Final Report - Corrections Required **Application No. DEPN-26-0068**

Description : single family residential development with optional ADU. 41 lots

Document Filename : DP Creekridge at Flying Horse Filing No 2.pdf

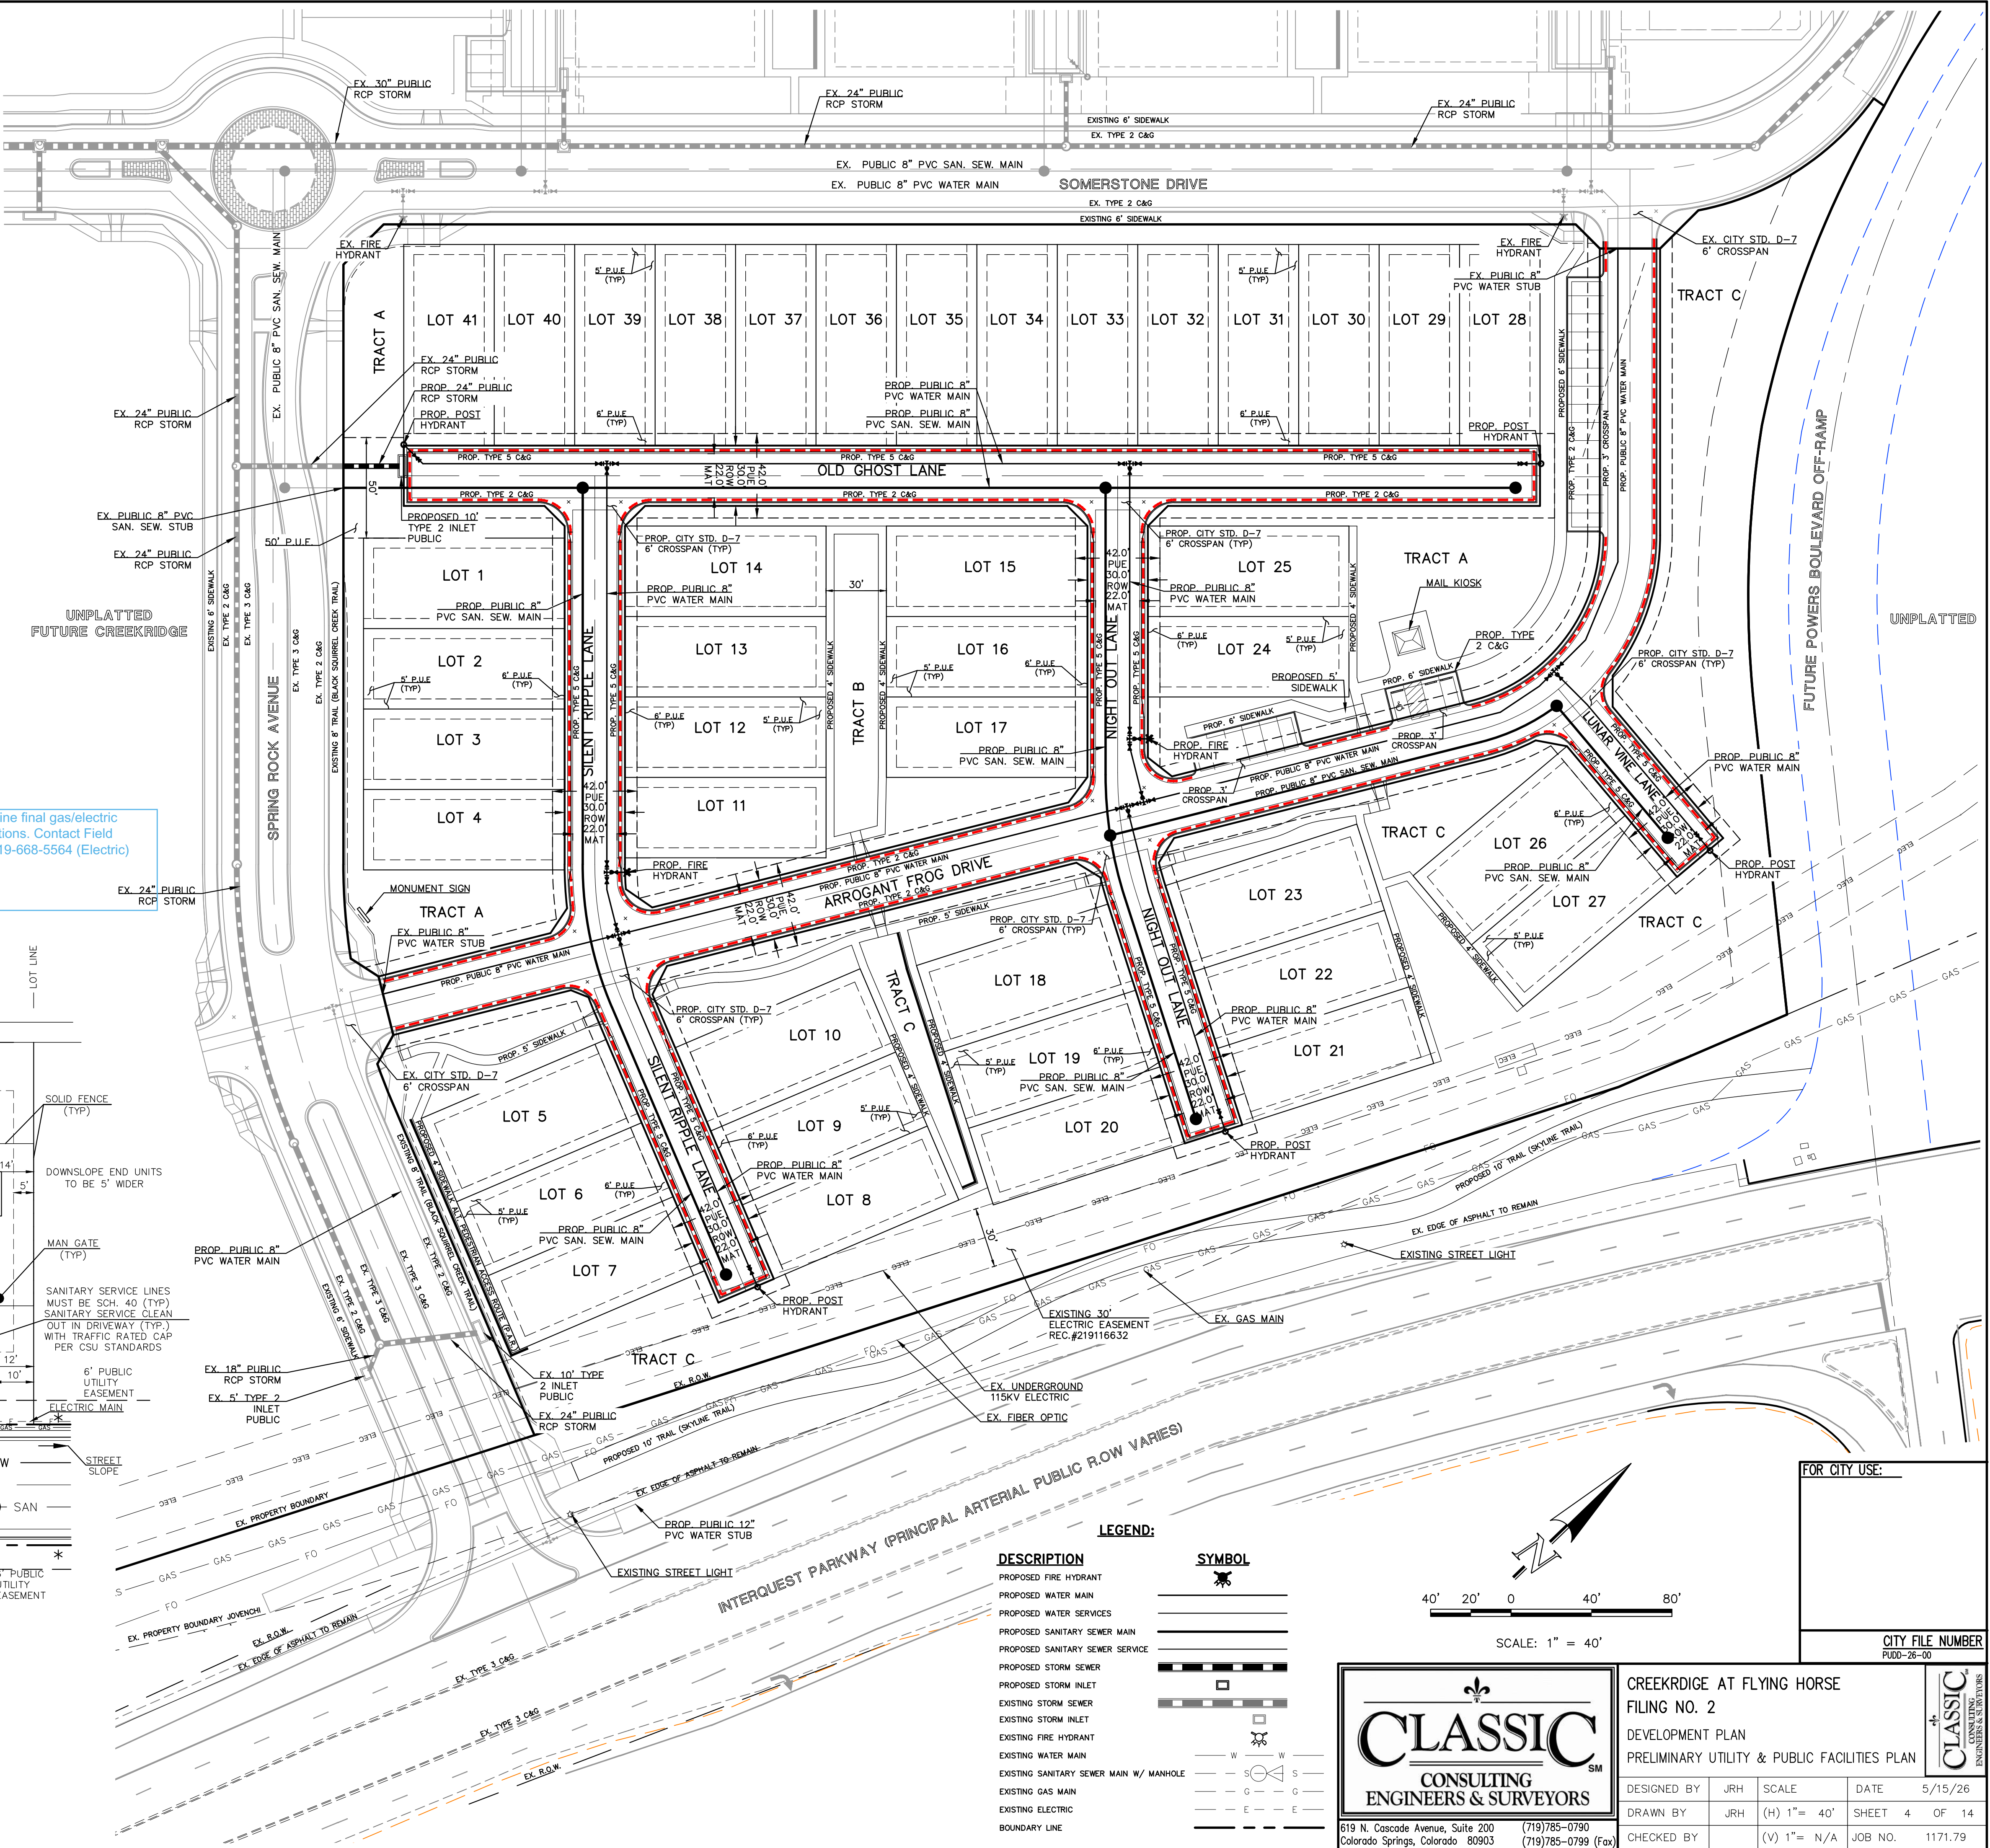
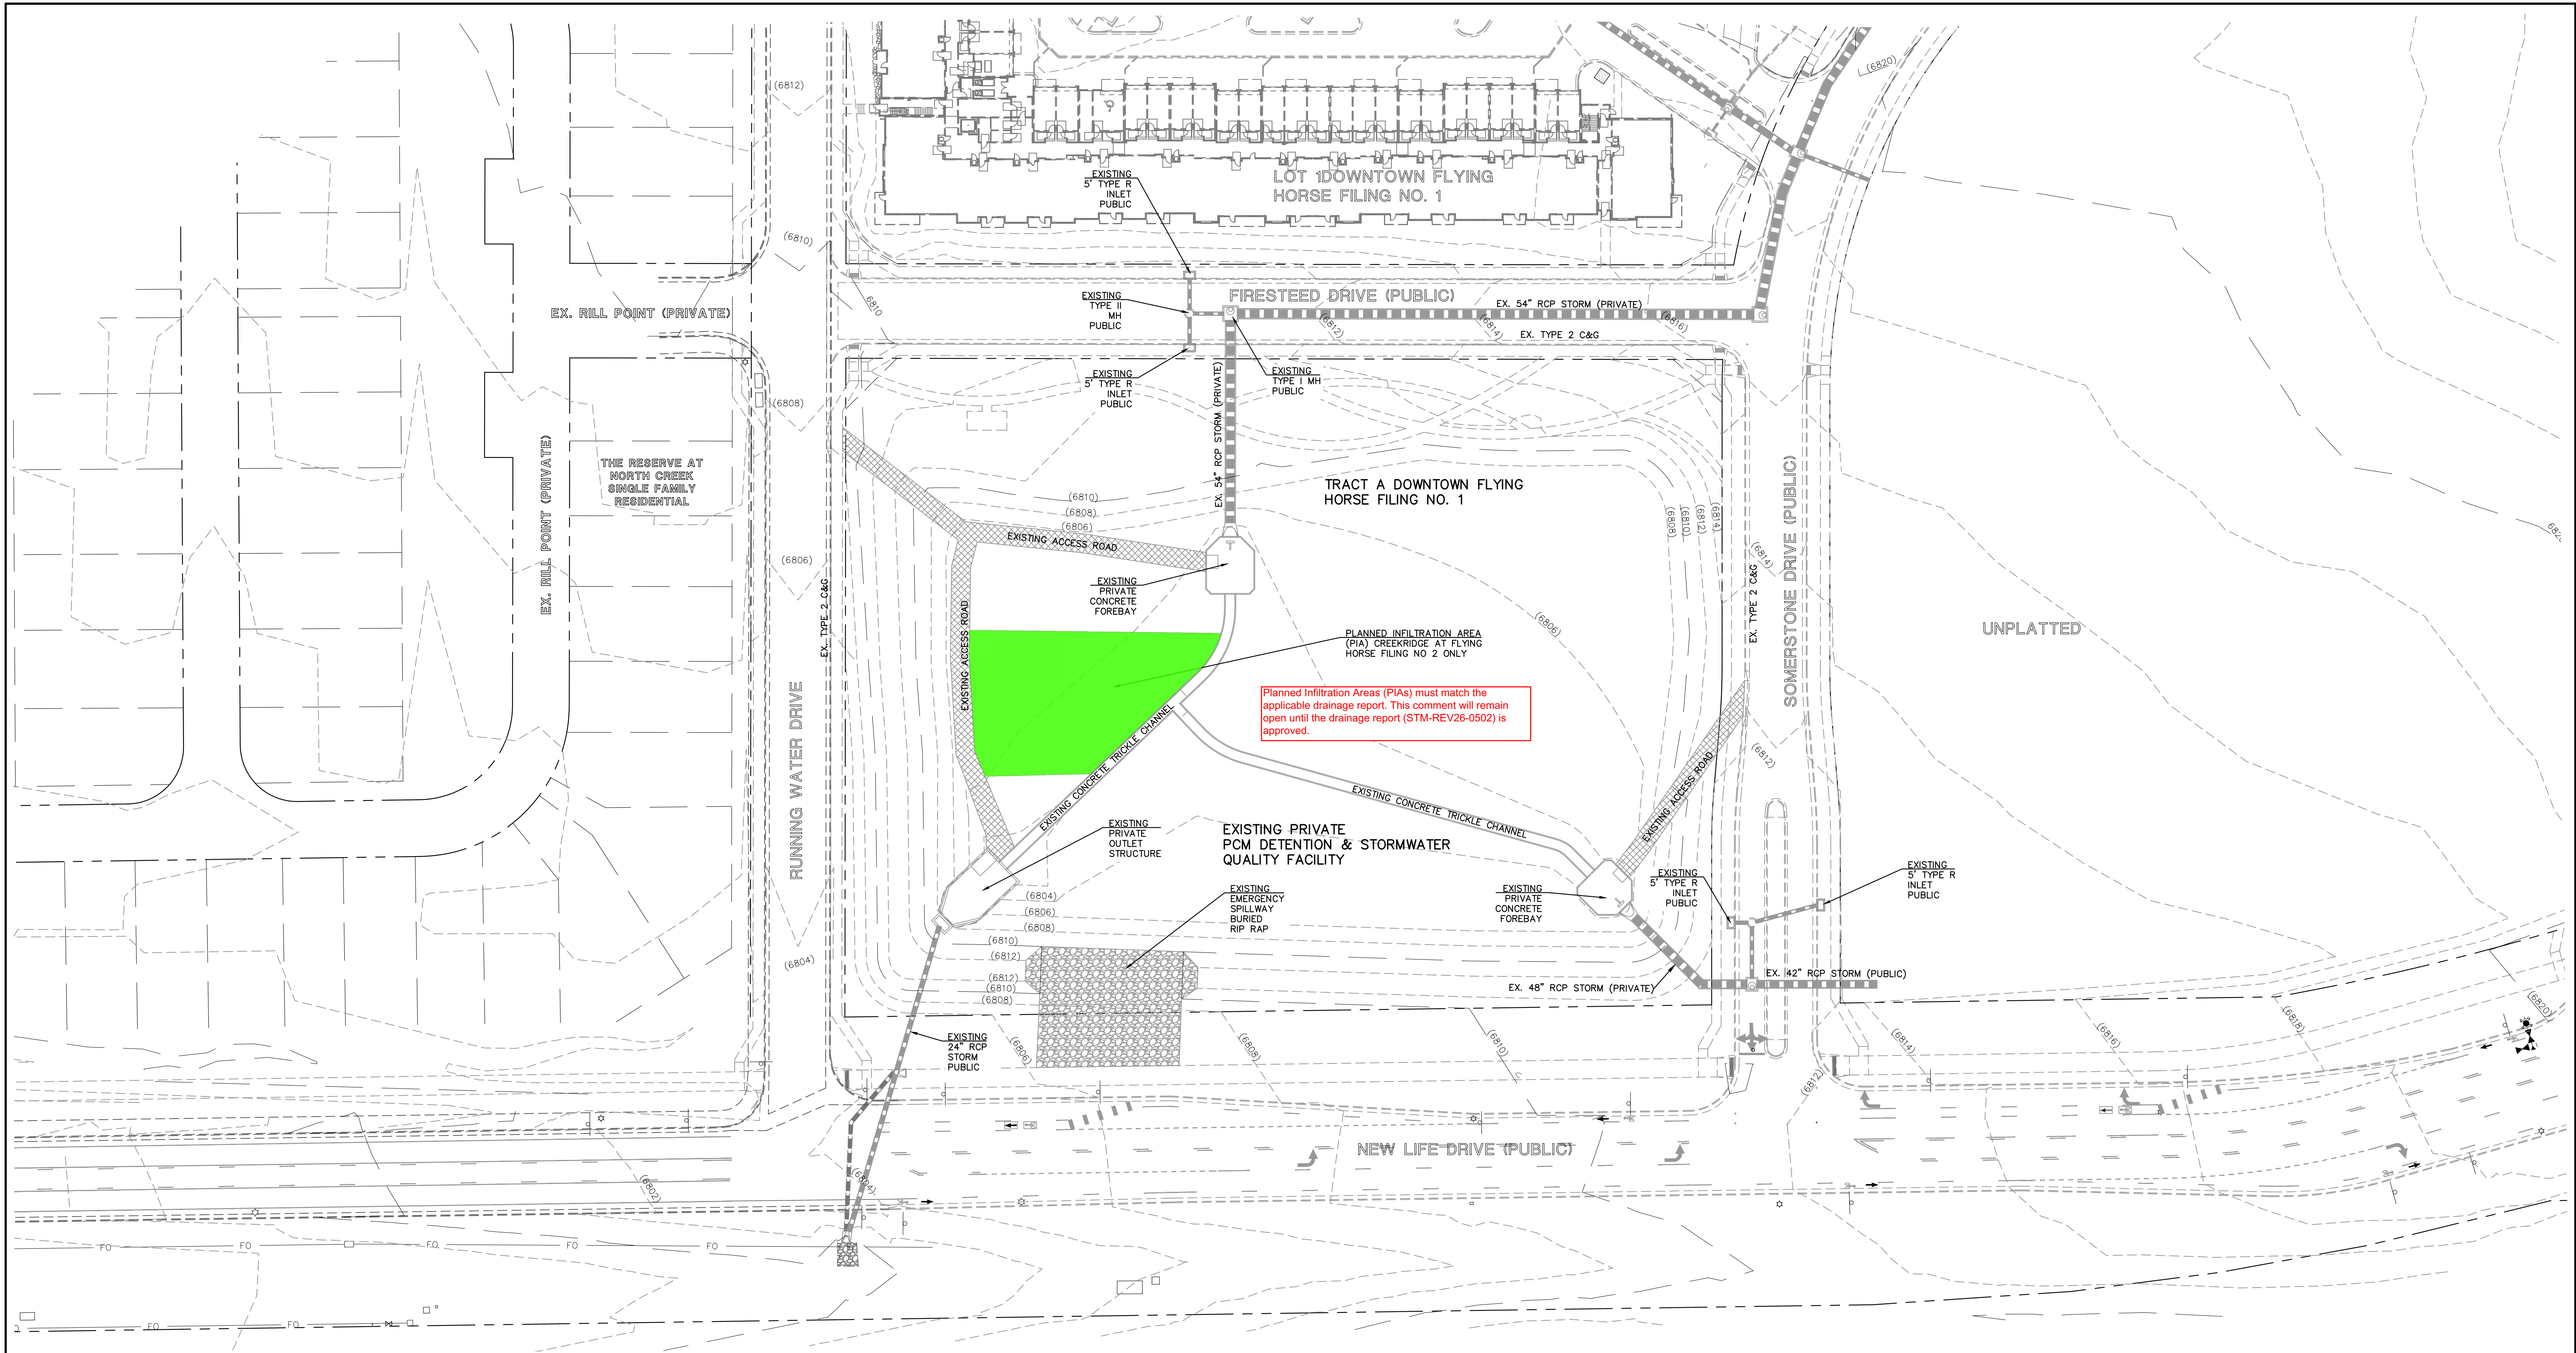
Show conceptual location of transformers for CSU

Add note "Gas meters must be a minimum of

Add "and service lines" per WLESS and VWLESS

Add note "CSU Field Engineer to determine final gas/electric meter, transformer, and service line locations. Contact Field Engineering at 719-668-4985 (Gas) or 719-668-5564 (Electric) with any questions."

Show gas main in center of road per detail GLESS A3-14

CREEKRDIGE AT FLYING HORSE
FILING NO. 2
DEVELOPMENT PLAN
PIA EXHIBIT

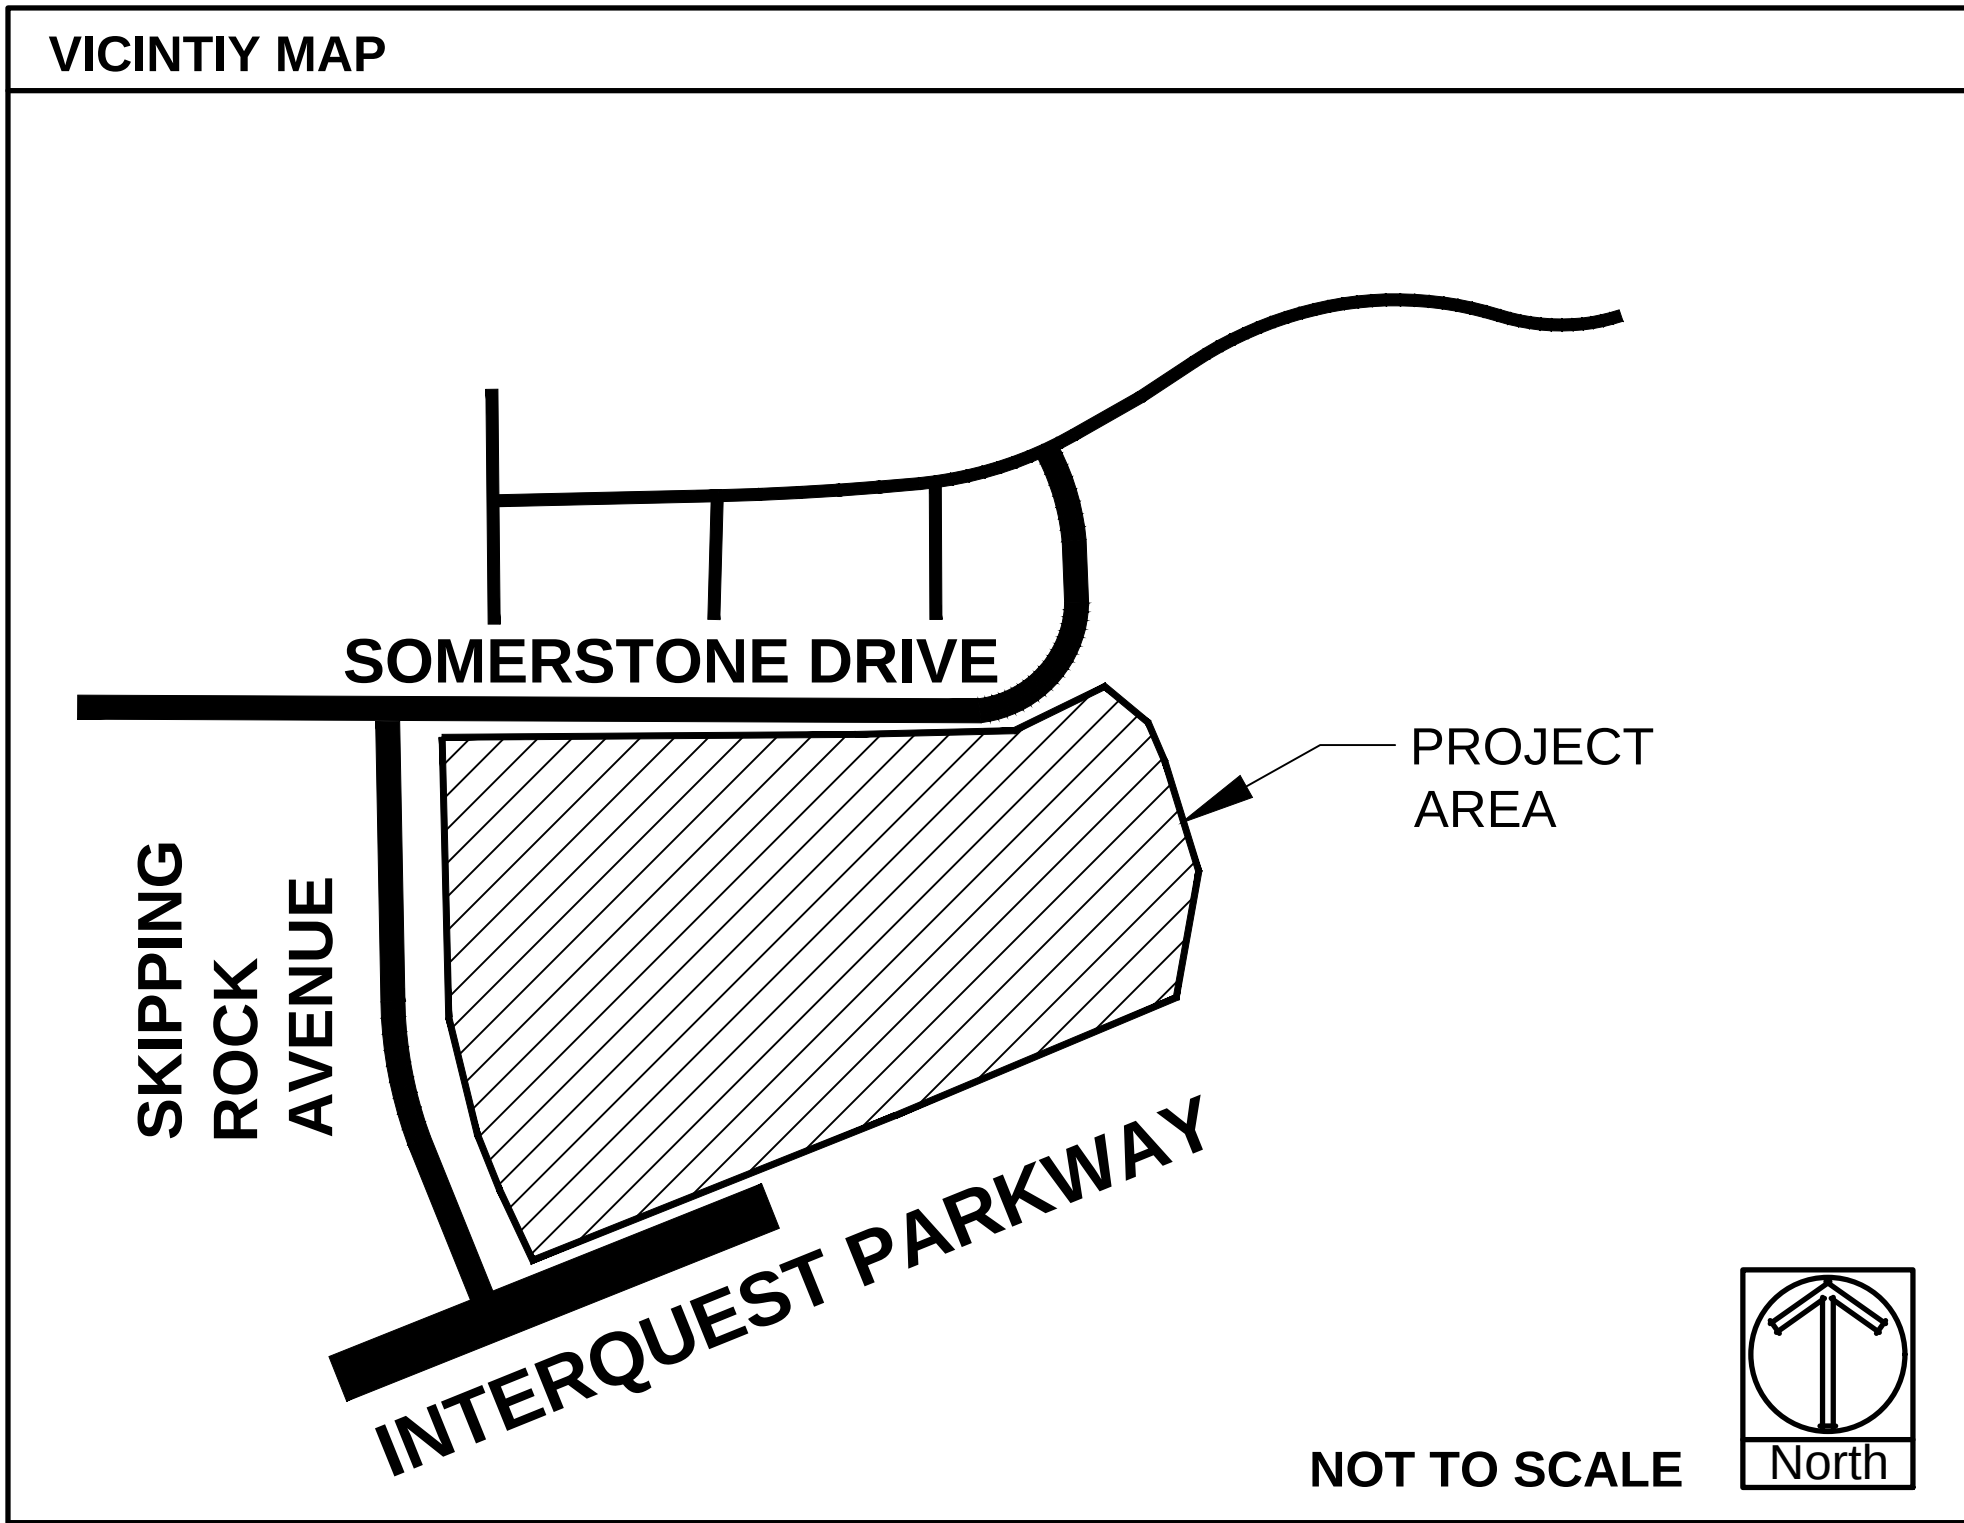
Planned Infiltration Areas (PIAs) must match the applicable drainage report. This comment will remain open until the drainage report (STM-REV26-0502) is approved.
